Subject: UNUSUAL NOISE WHEN STARTING TO MOVE VEHICLE WHILE STEERING WHEEL IS TURNED TO FULL LEFT POSITION	Bulletin No: 06-002/14
	Last Issued: 07/29/2014

- This bulletin supersedes the previous bulletin 06-002/13, issued on 10/09/13. The APPLICABLE MODEL(S)/VINS, DESCRIPTION, REPAIR PROCEDURE, PART(S) and WARRANTY INFORMATION have been revised.
- Changes are noted below in Red beside the change bar.

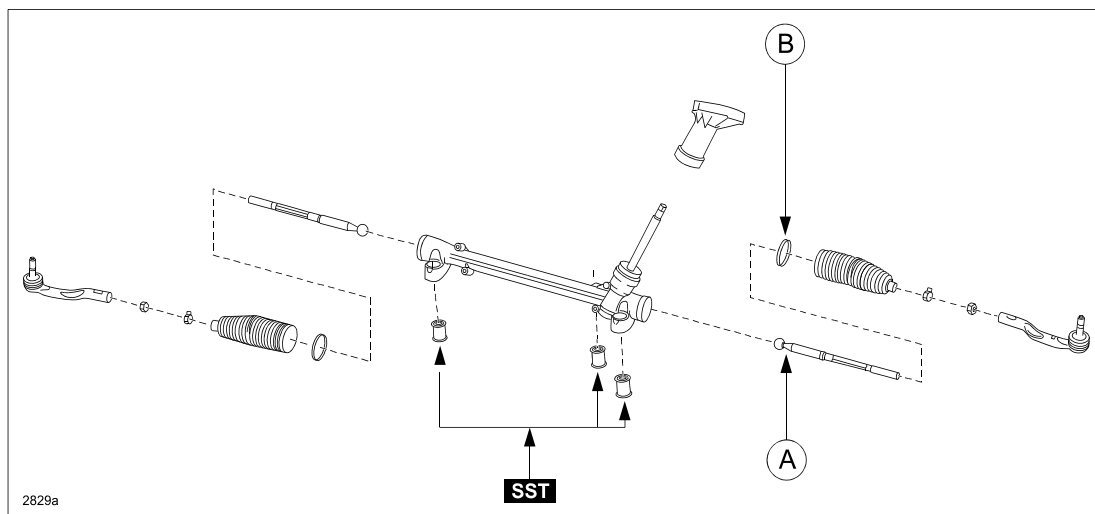
The noise is caused when the edge of the left side inner ball joint (A) gets stuck with the steering gear housing. The following modifications have been made to eliminate the noise:

1. The shape of the inner ball joint edge has been changed.
2. Grease has been applied to the inner ball joint edge.

Grease Application Procedure:

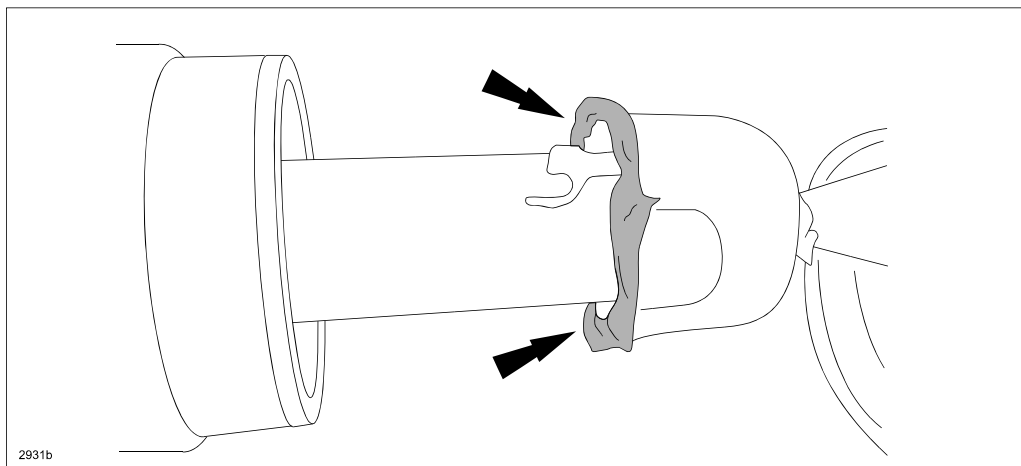
1. Squeeze approx. 1cc of grease out of the tube onto your finger.

2. Apply the grease all the way around the inner ball joint edge.
